RE: VB BTS II, LLC
Site Name: US-FL-7108 Myerlee
Project: DCI2024-00010
Response to Staff Comments Dated April 12, 2024

RE: VB BTS II, LLC – US-FL-7108 Myerlee
Revised Project Narrative
PUD Amendment DCI2024-00010

Wood Stork Colonies Map - Myerlee

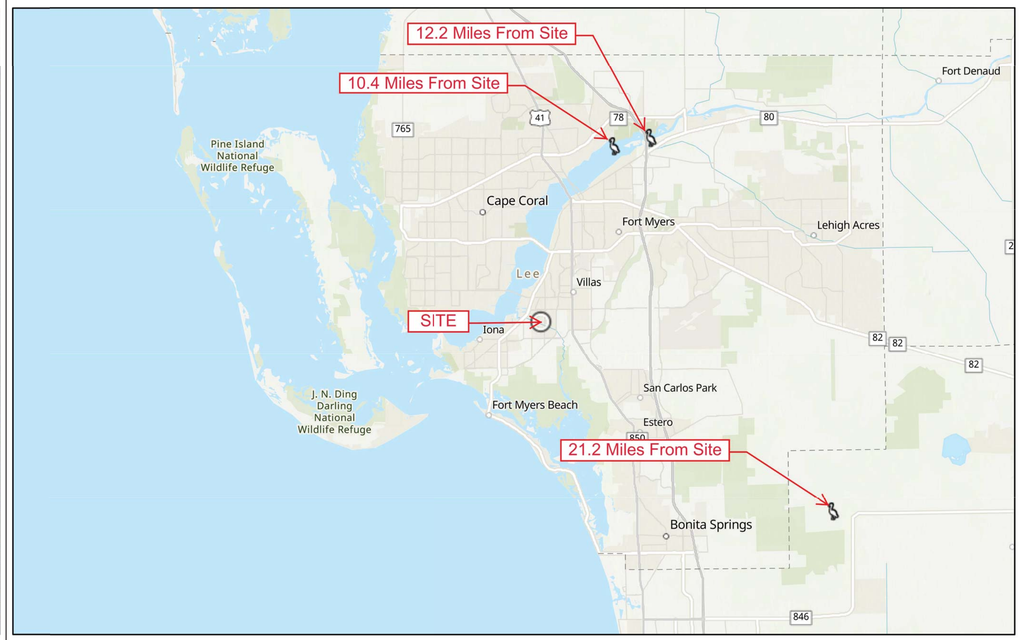
2. Please provide a map of the nearest eagle location in relation to the proposed cell tower (please provide the physical location of the nest in relation to the project, as well as the approximate distance).

3. Please provide a map of the woodstork foraging habitat location in relation to the proposed cell tower (please provide the physical location of the woodstork foraging habitat in relation to the project, as well as the approximate distance).

The nearest bald eagle nest is located approximately 0.7 miles to the Southwest while the nearest wood stork colony is located approximately 10.4 miles to the Northeast. Please see Sheet C-1.0.2.

Please see Sheet C-1.0.2.

SHEET NUMBER:
C-1.1

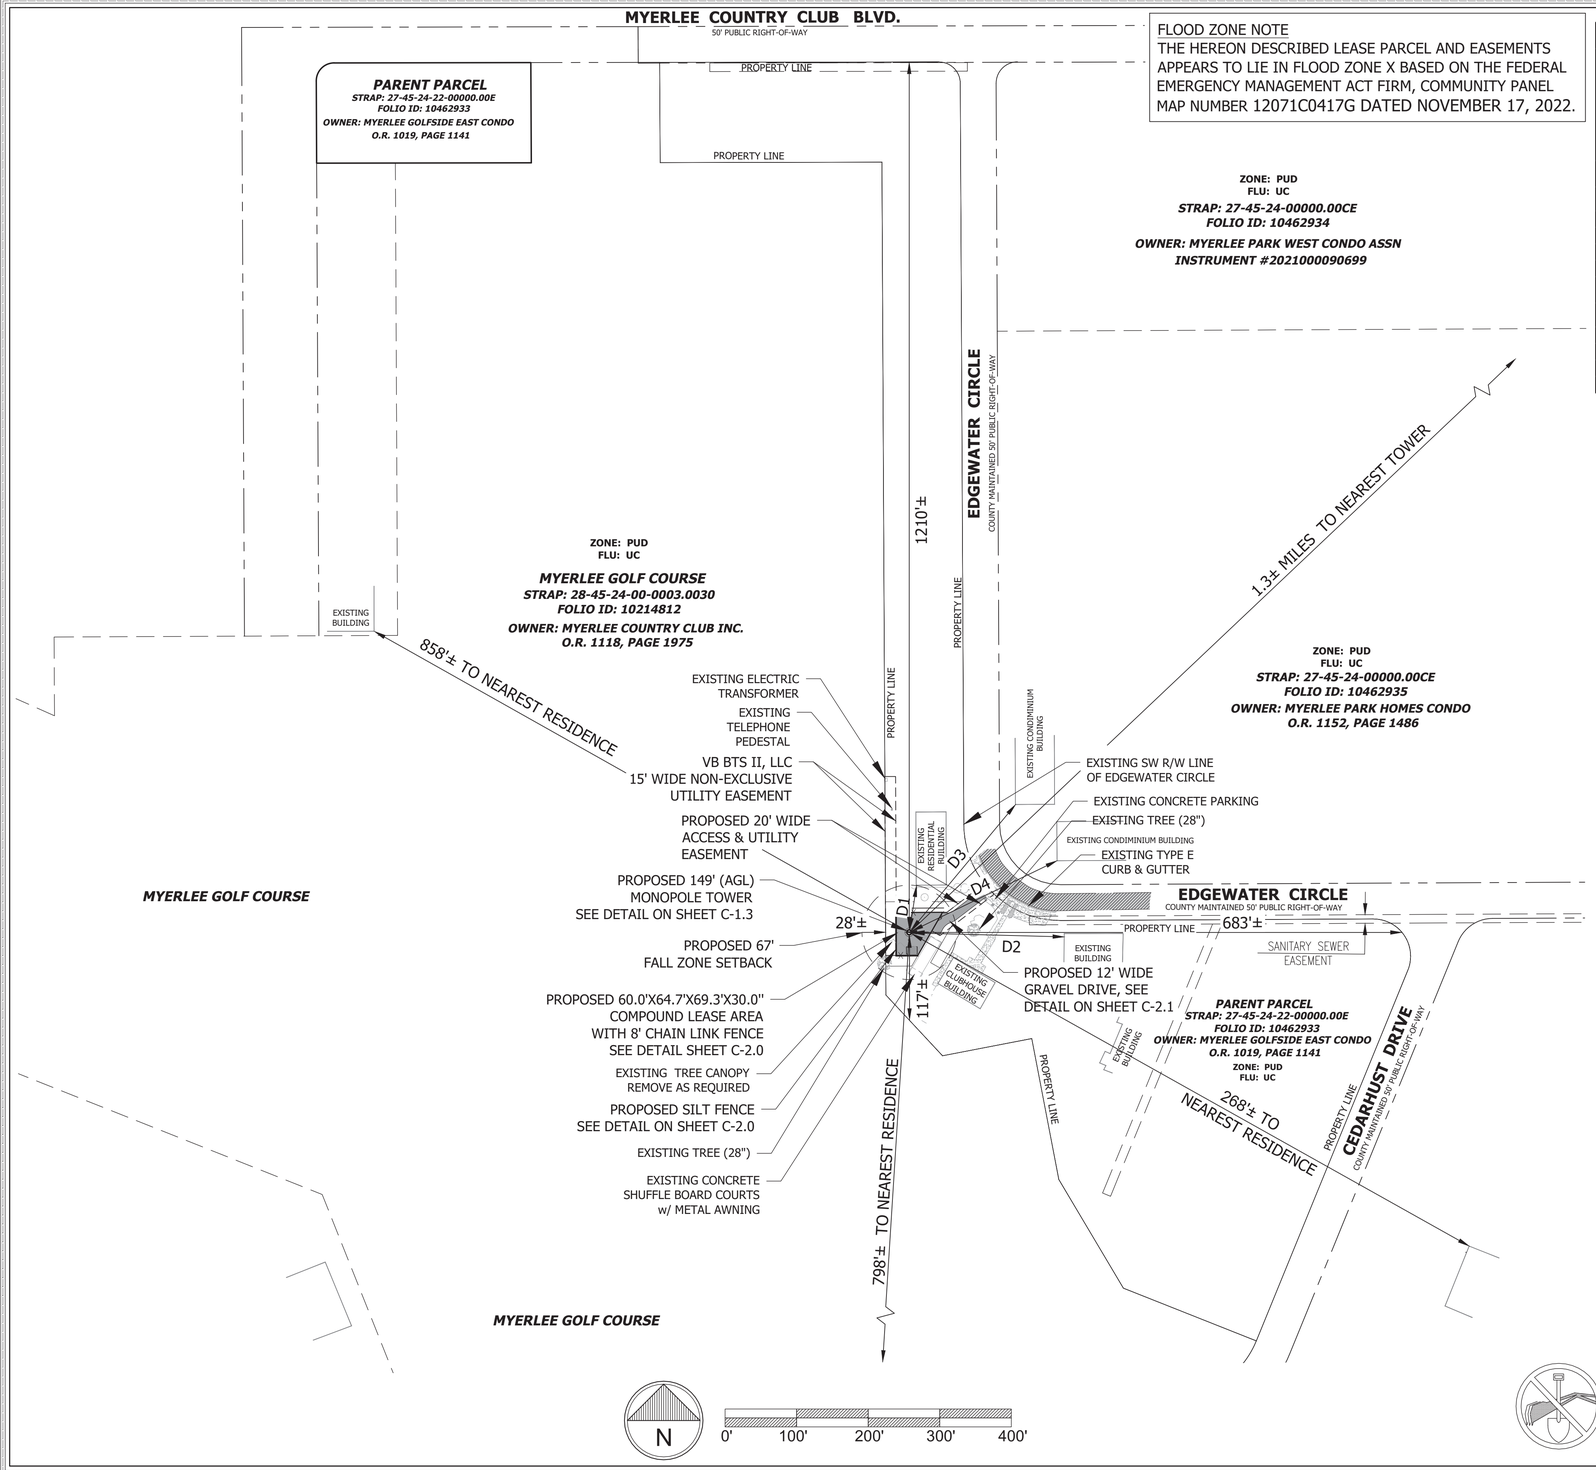
6. Tower height setback must be measured from the exterior of the tower, not the center. Please provide updated plans to demonstrate this.

The setbacks and separations depicted on Sheets C-1.0 and C-1.1. are measured from edge of the Monopole while the distances on Sheet C-2 are measured from the Monopole's centerline. Sheet C-2 now depicts distances from the edge of the Monopole.

SHEET NUMBER:
C-1.2

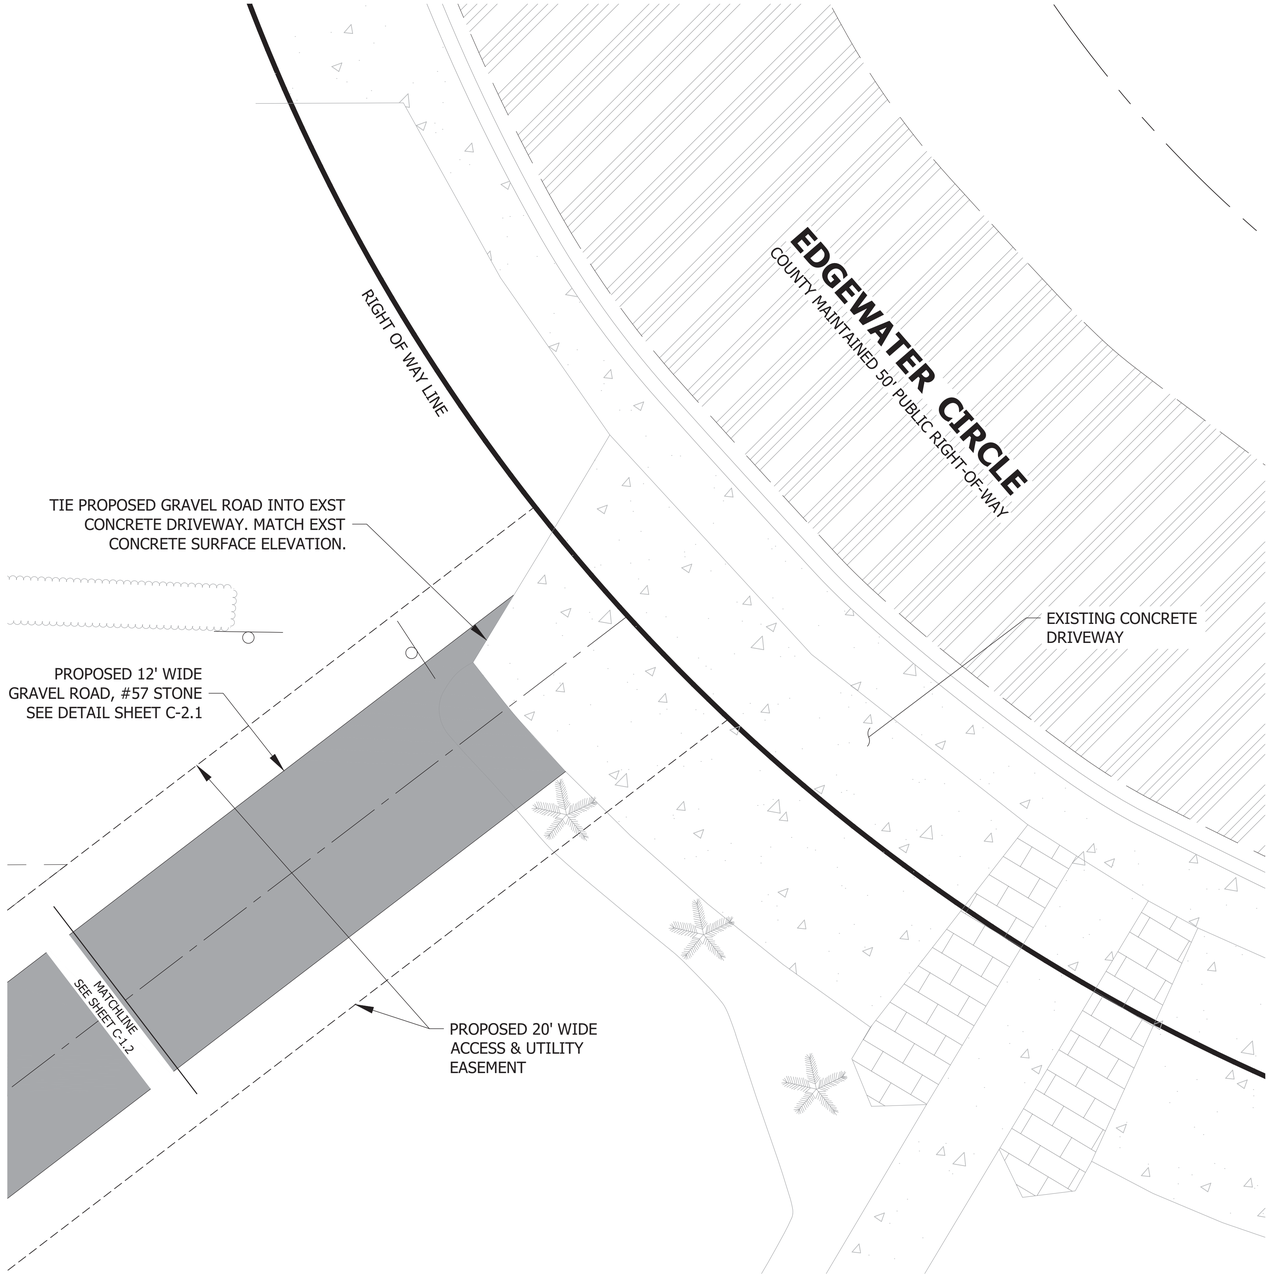
8. The applicant is indicating the removal of a canopy tree as part of the development foot print. Please describe how the removal affects the general tree calculation as part of the parent parcels development. If it is impacting the general tree requirement, please indicate how the applicant intends on offsetting the impact.

11. The applicant is not proposing any screening/ buffering near the amenity center. Please note that this does not meet lee plan policy 6.1.6 and 5.1.5. Please indicate how the applicant intends to screen the development to the multi-family residents.

The Monopole is sited so that it will require the removal of one strangler fig. Vertical Bridge respectfully submits removal in this instance is necessary due to the poor health of the tree. Please see Sheet C-1.2 as well as the enclosed arborist report dated September 9, 2024.

Landscape buffer plantings are not proposed along Southeast side of the compound because there is no space between the compound and the shuffle board courts. The compound is as small as possible while still providing the Monopole with the ability to collocate multiple users, as required under the LDC. All required plantings will be placed immediately to the East of the Shuffleboard Court, between the court and the clubhouse. This configuration will meet the sound planning objective of providing buffering on the southeast side while also providing the LDC required buffering between the Monopole's compound and the semi-public space of the golf course and providing a LDC required buffer plantings. Please see Sheets C-1.2 and L-1.

1 TREE PLANTING DETAIL
SCALE: N.T.S.

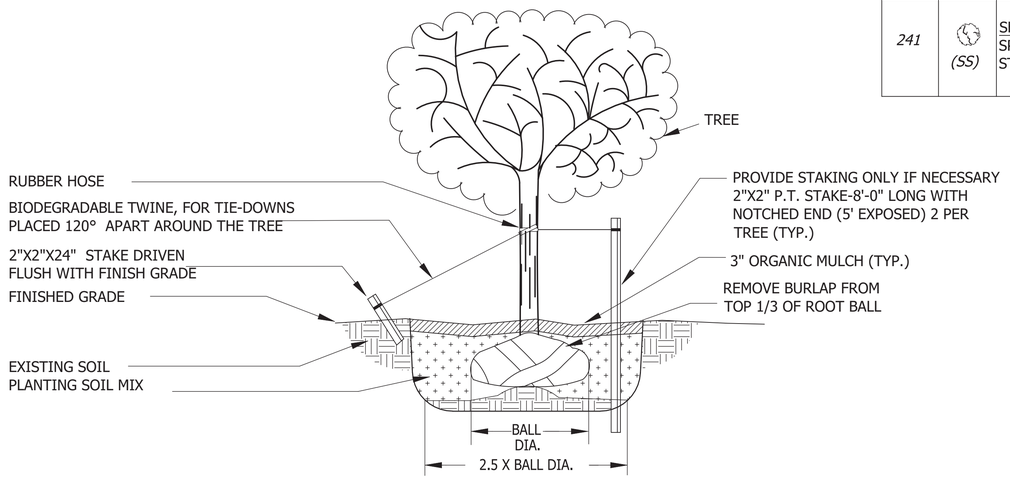
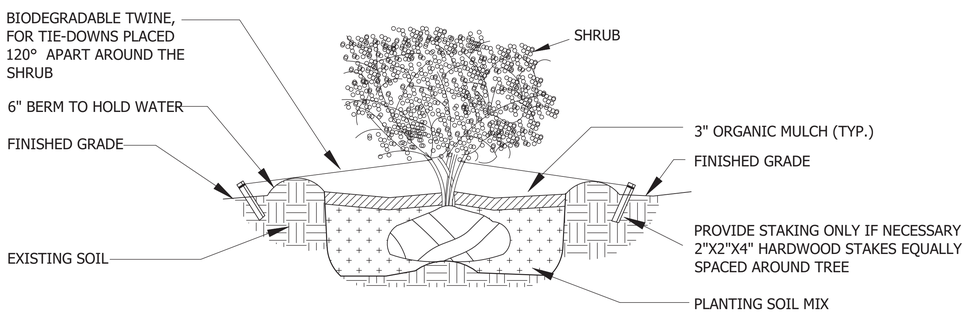
10. The landscaping proposed does not depict a double hedge row per LDC 34-1447(d)(4)(c)(2). Please provide a revised plan. Please note that landscaping must meet 34-1447(D)(4)(c) and will be conditioned at time of staff report.

The landscape plan has been revised to meet LDC planting requirements. Please see Sheet L-1.
